# ALERT SERVICE BULLETIN

**TITLE:** Rotor Head - Addition of paint lines to each side of the tail rotor hub body and splined flange assembly for visual inspection of tightening torque

| Model:   | EC120 |

Figure 1

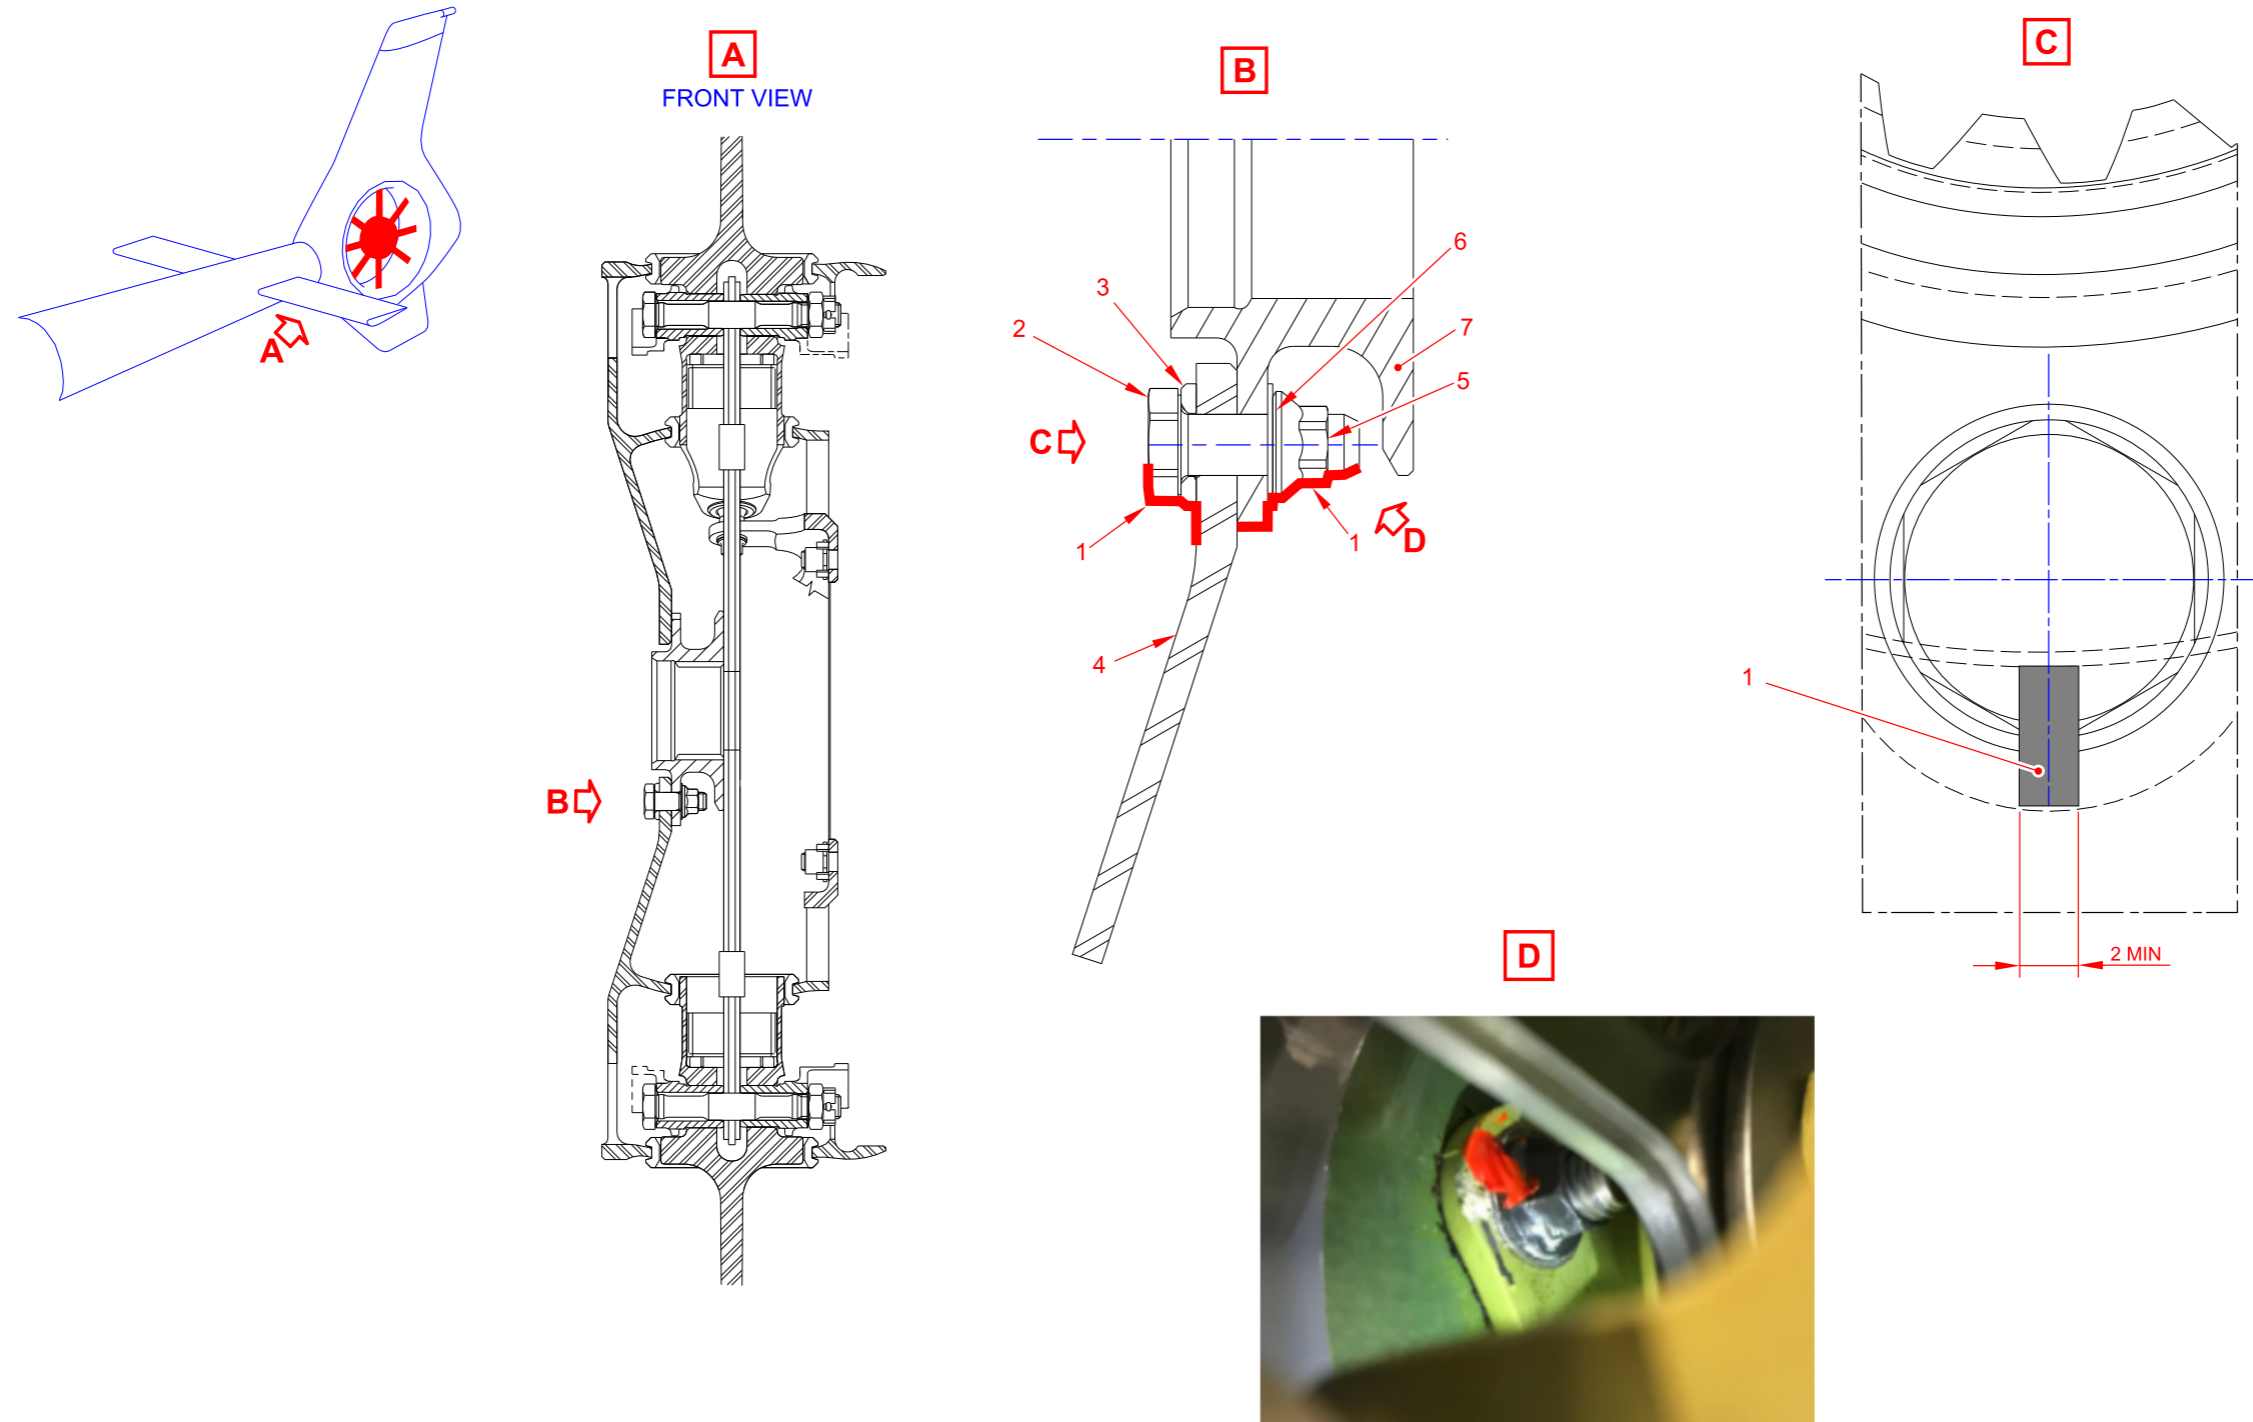
- 4.1. Apply the paint lines on the links between the tail rotor hub and the tail rotor splined flange.
  - 4.1.1. Remove the tail rotor hub. Refer to [AMM 64-21-00, 4-1](#) .
  - 4.1.2. Do a check of the torque value of the assembly hub body. Refer to [MTC 20-02-05-404](#) and [AMM 64-21-00, 4-4](#) .
  - 4.1.3. Apply a paint line to the screw (2), washer (3) and tail rotor hub (4) with Paint, Polyurethane (1).
  - 4.1.4. Apply a paint line to the nut (5), washer (6) and splined flange (7) with Paint, Polyurethane (1).

Make sure that the width of the mark is more than 2 mm on both sides.
